SERVICE BULLETIN

ENGINE - HP TURBINE ROTOR AND STATOR ASSEMBLY - PROVIDE NEW STAGE 2 HPT VANES -
CATEGORY CODE 8 - MOD.ENG-72-0237

V2500-ENG-72-0237

Location of the Stage 2 High Pressure Turbine (HPT) Vane Assemblies
Fig.1

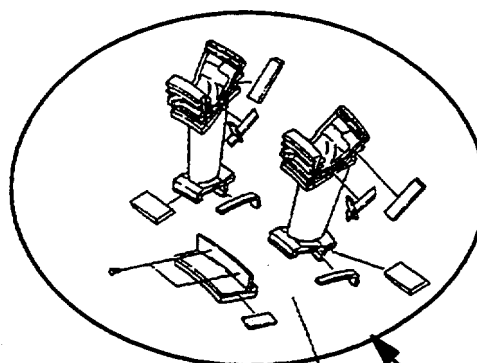
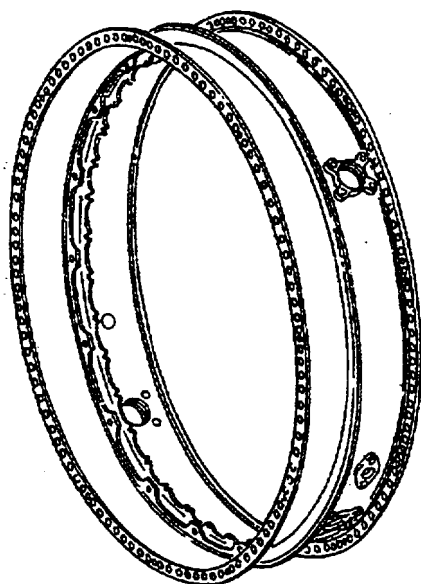
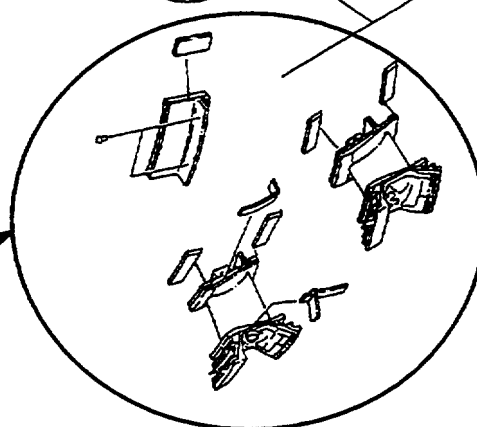
(2) Install new or modified Stage 2 HPT Vane Assemblies.

INSTALL THE
2A3812 RING
SEGMENT AND
VANE CLUSTER
ASSEMBLY (17 off)

INSTALL THE
2A3822 RING
SEGMENT AND
VANE CLUSTER
ASSEMBLY (2 off)

Location of the Stage 2 High Pressure Turbine (HPT) Vane Assemblies
Fig.2(Sheet 1)

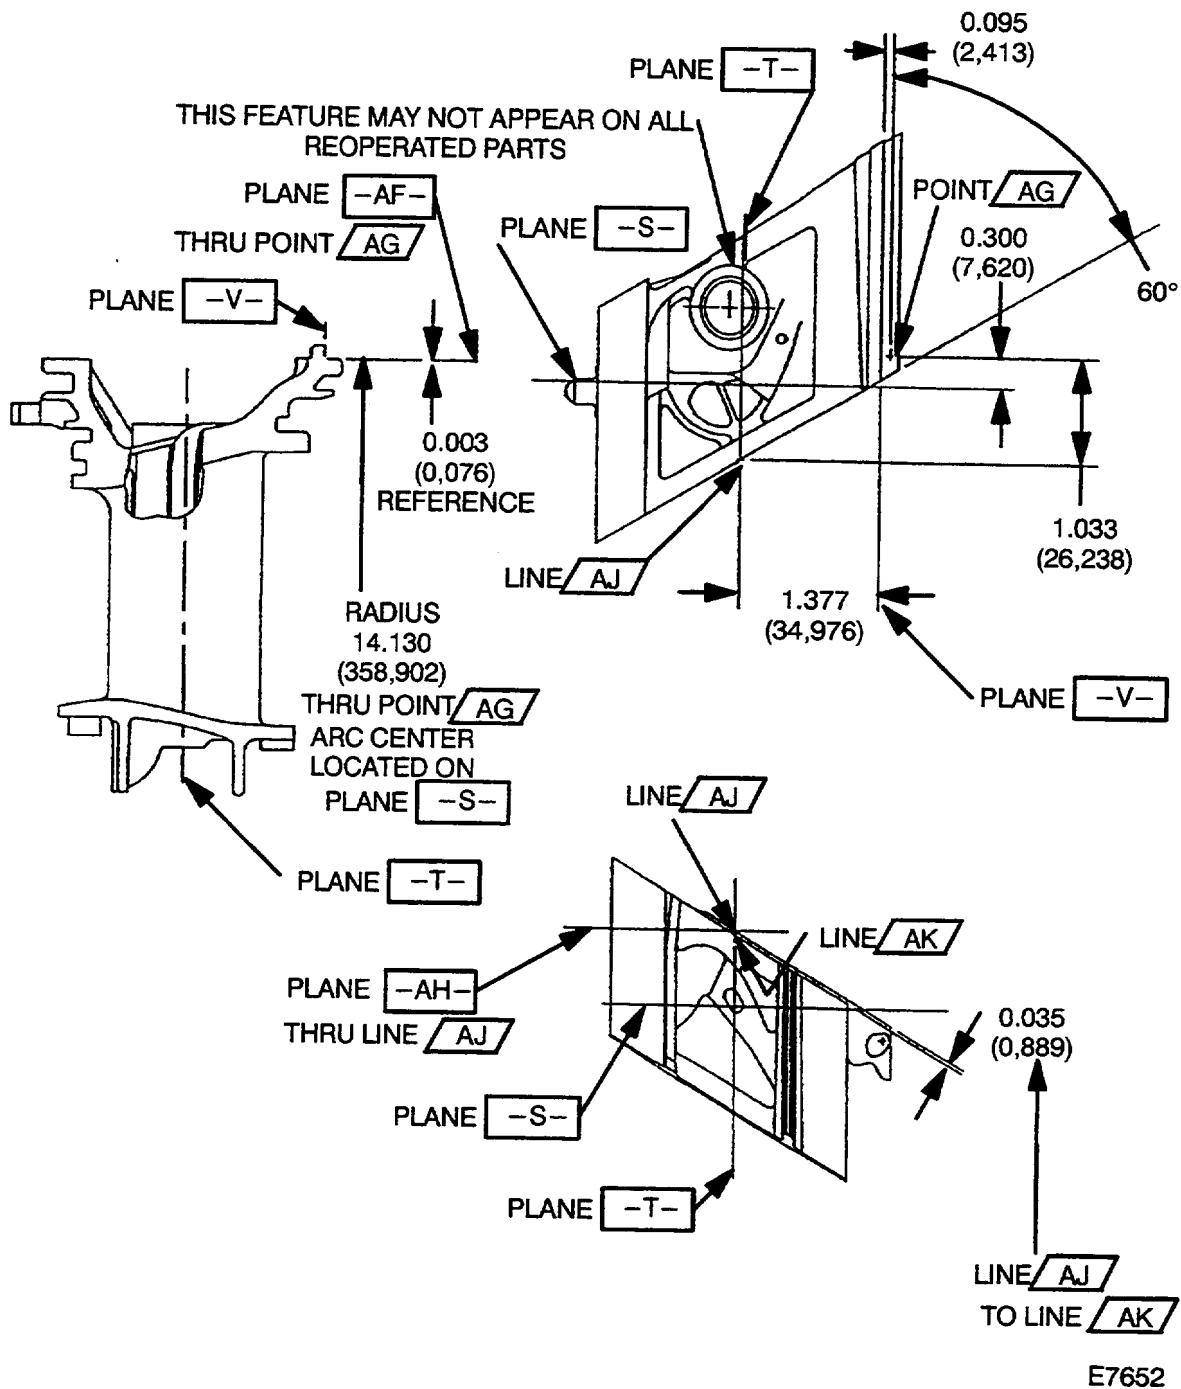
- (a) Set-up machine one hole to 0.075 - 0.081 in. (1,905 - 2,057 mm) diameter. The electrodischarge machining method given in TASK 70-32-03-320-501 can be used.

Refer to Figures 1 and 2. Reference (2), Chapter/Section 70-32-03, Finish by Electrochemical or Electrodischarge Metal Removal.

Modification of the Stage 2 High Pressure Turbine (HPT) Vane Assemblies
 Fig.2(Sheet 2)

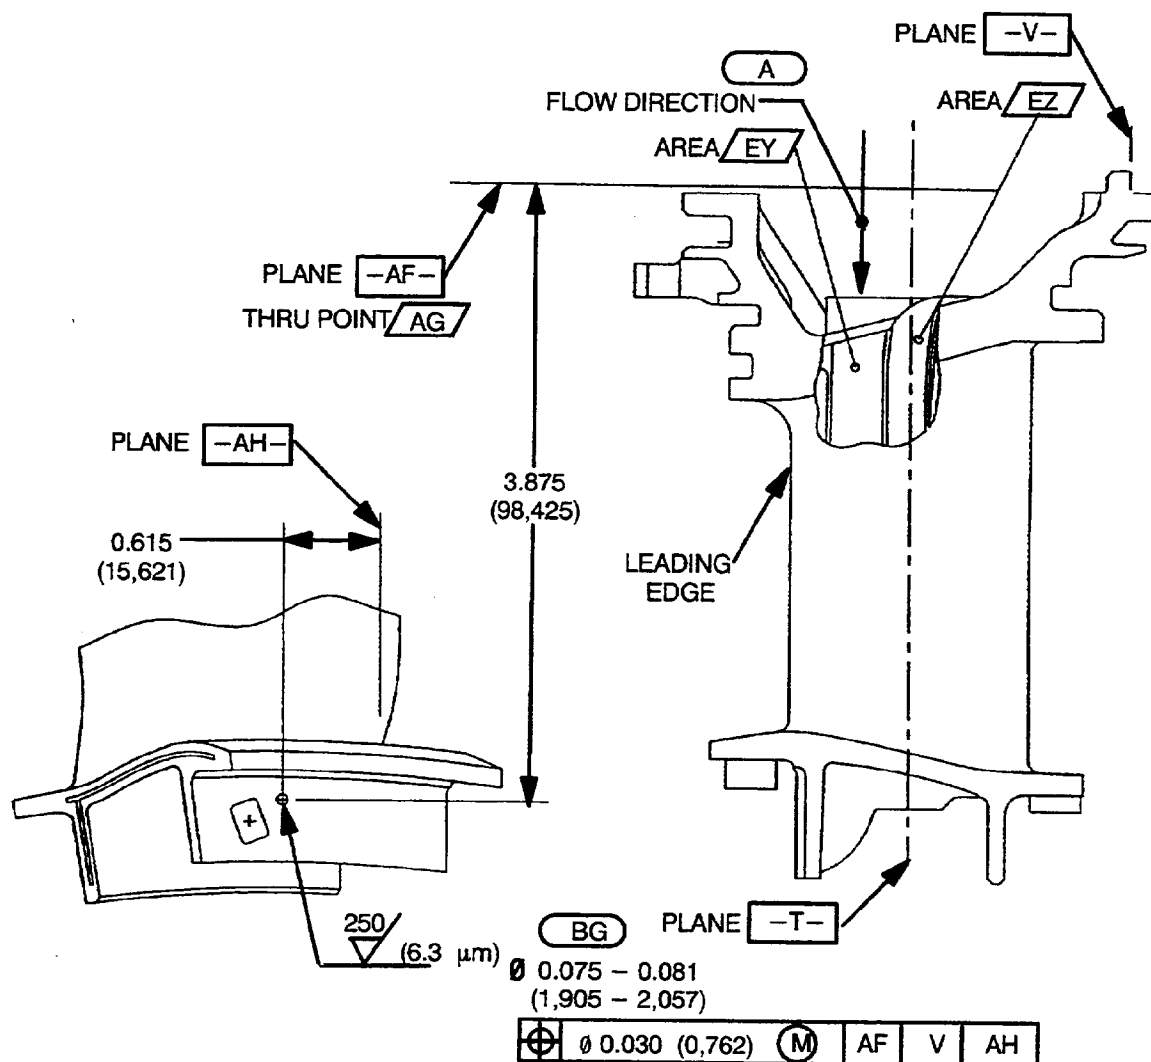
- (b) Flow test passage EY in direction shown with area EZ and leading edge shower head (4 rows total) holes blocked by the procedure specified.

- (c) Mark the new part number adjacent to the existing part number. Use the vibration peen method

$\left(\frac{P_3}{P_a} \right)_{\min}$	$\left(\frac{P_3}{P_a} \right)$ TARGET REFERENCE	$\left(\frac{P_3}{P_a} \right)_{\max}$
$\frac{W}{P_a} T_3 = .0184$	BASIC LIMIT	1.412	1.500	1.621

BG FINISH SURFACE OF THIS PART BY PROCEDURE GIVEN IN TEXT. BREAK EDGE NOT REQUIRED
 UNLESS DIFFERENTLY SPECIFIED BREAK SHARP EDGES 0.030 (0,762)
 UNLESS DIFFERENTLY SPECIFIED ALL SURFACE TEXTURES ARE TO BE 125 (3.2 μm) E7653

Family Tree - HPT Case and vane Assembly Ref. Catalog Sequence No. 72-45-20. Fig. 01
Item 005
Fig.3

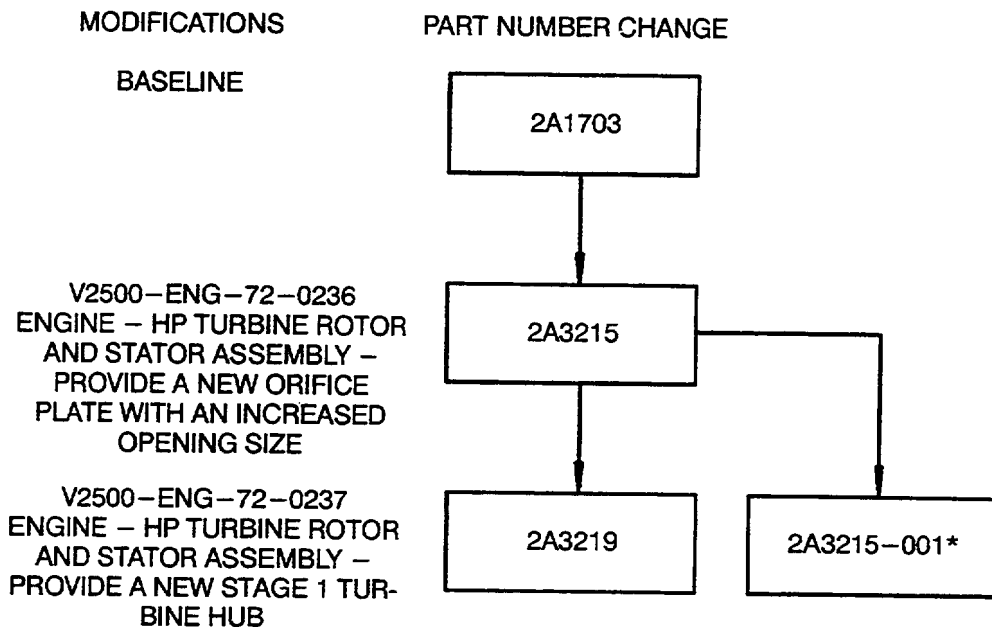
- (c) Use the vibration peen method specified in Reference (2), Chapter/Section 70-09-00, Marking of Parts.
- (3) When you assemble the HPT Case and Vane Assembly by the procedure specified in Reference (5) or (6), Chapter/Section 72-45-20, Assembly it is permissible to intermix Ring Segment and Vane Cluster Assemblies 2A3372 with 2A3812 and 2A3472 with 2A3822.

- (a) Identify the new assembly as 2A3215-001.
 - (b) Mark the new part number adjacent to the existing part number.
 - (c) Use the vibration peen method specified in Reference (2), Chapter/Section 70-09-00, Marking of Parts.

*THIS ASSEMBLY CONTAINS A MIXTURE OF RING SEGMENT AND VANE
CLUSTER ASSEMBLIES 2A3372 WITH 2A3812 AND 2A3472 WITH 2A3822

Family Tree - Ring Segment and Vane Cluster Assembly Ref. Catalog Sequence No.
72-45-24. Fig. 02 Item 050
Fig.4

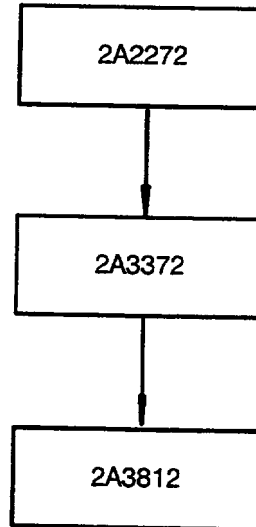
- (a) Identify the new assembly as 2A3812 or 2A3822, as applicable.

- (b) Mark the new part number adjacent to the existing part number.

Family Tree - Stage 2 High Pressure Turbine Vane Assembly Ref. Catalog Sequence No.
72-45-24. Fig. 02 Items 130 and 350
Fig.6

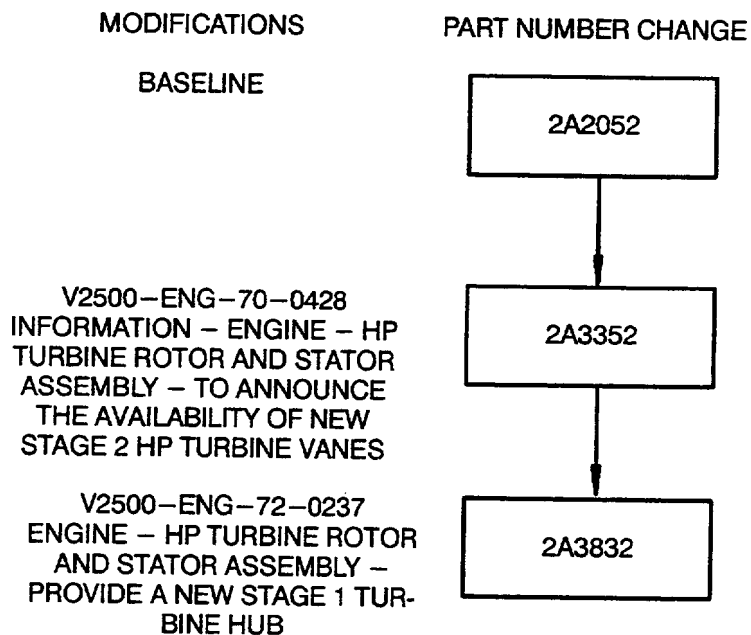
Existing	New Part Number
2A3352	2A3832
2A3452	2A3842
